Subject: SLIC Case RO0002913 and Geotracker Global ID T06019748481, Perciva/Metro Valley Cleaners, 224 Rickenbacker Circle, Livermore, CA 94550

Alameda County Environmental Health (ACEH) staff has reviewed the Spills, Leaks, Investigations, and Cleanups (SLIC) case file for the above referenced site including the recently submitted document entitled, "Work Plan for Additional Site Characterization," dated June 1, 2007 and revised July 9, 2007. The Work Plan was received by ACEH on July 27, 2007 and prepared on your behalf by Engeo, Incorporated in response to ACEH correspondence dated June 26, 2007.

# Revised Figure 4

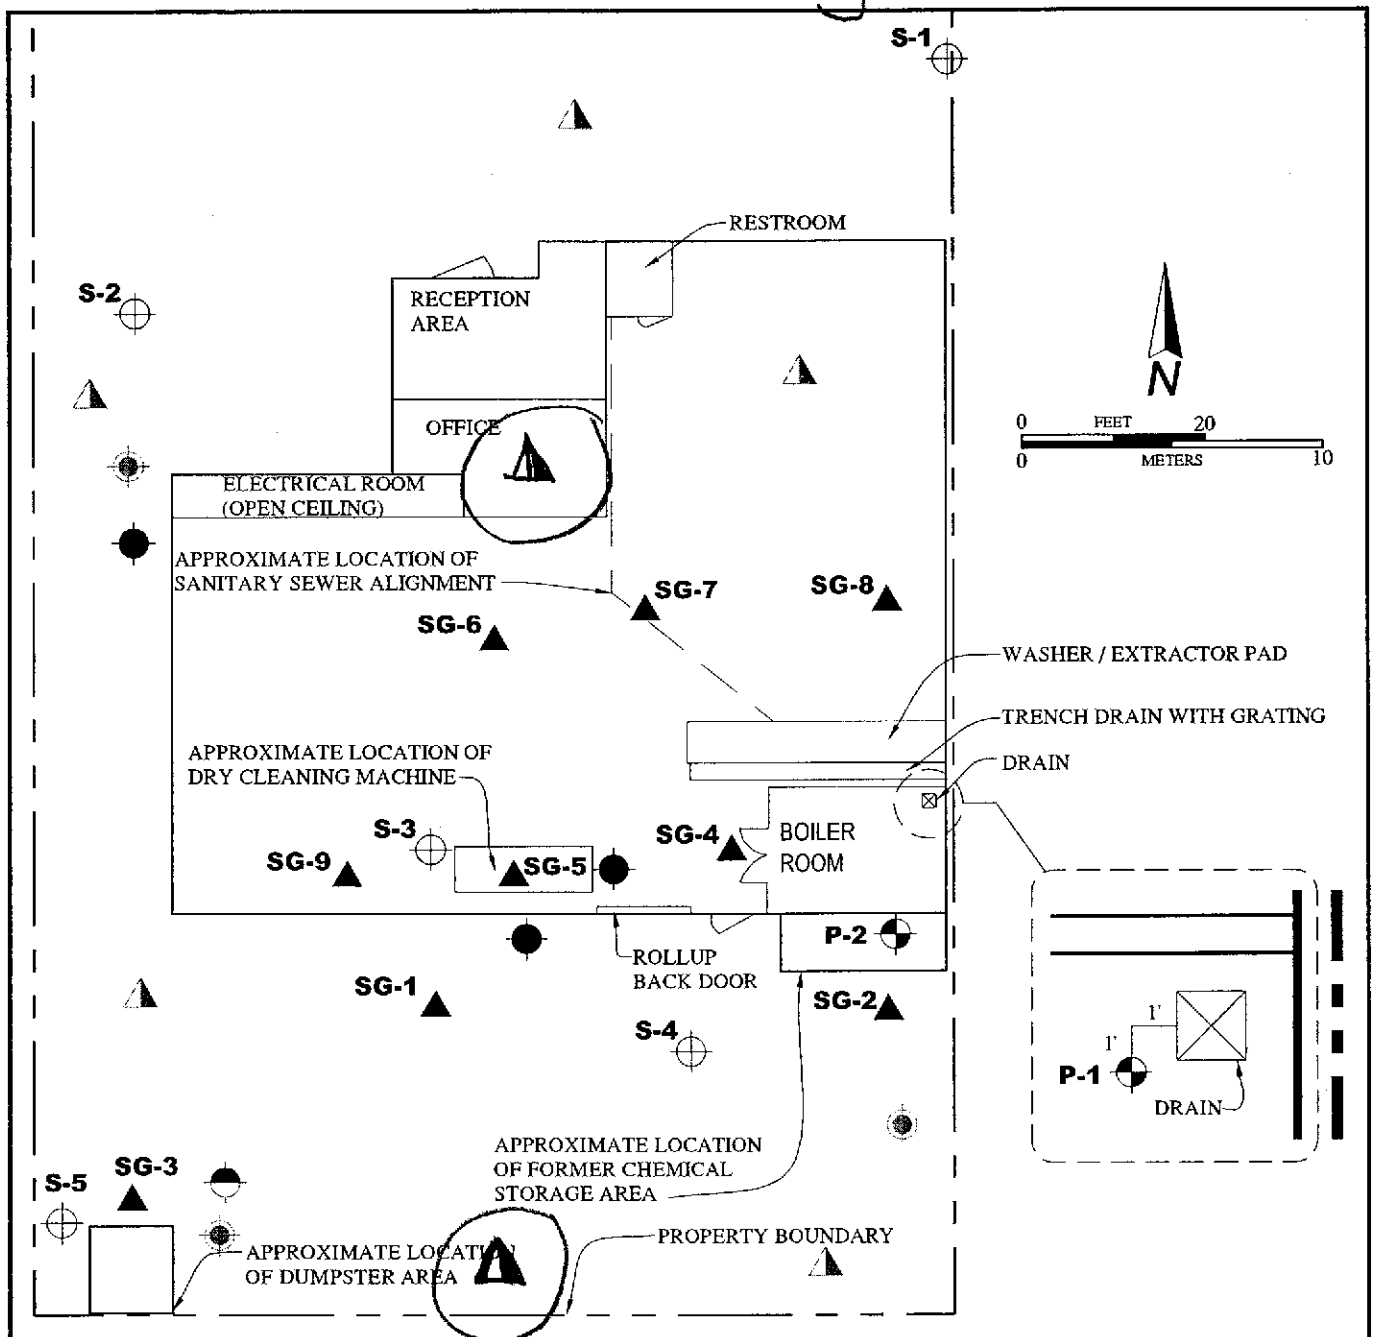
1. **Additional Soil Vapor Sampling.** The proposal to collect five additional soil vapor samples using protocols and procedures that are consistent with, "Advisory – Active Soil Gas Investigations," dated January 13, 2003 (Los Angeles Regional Water Quality Control Board and DTSC) is generally acceptable. However, we request the two additional soil vapor samples be collected at the sampling locations shown on the attached Revised Figure 4. Please present the results of the soil vapor sampling in the Site Assessment Report
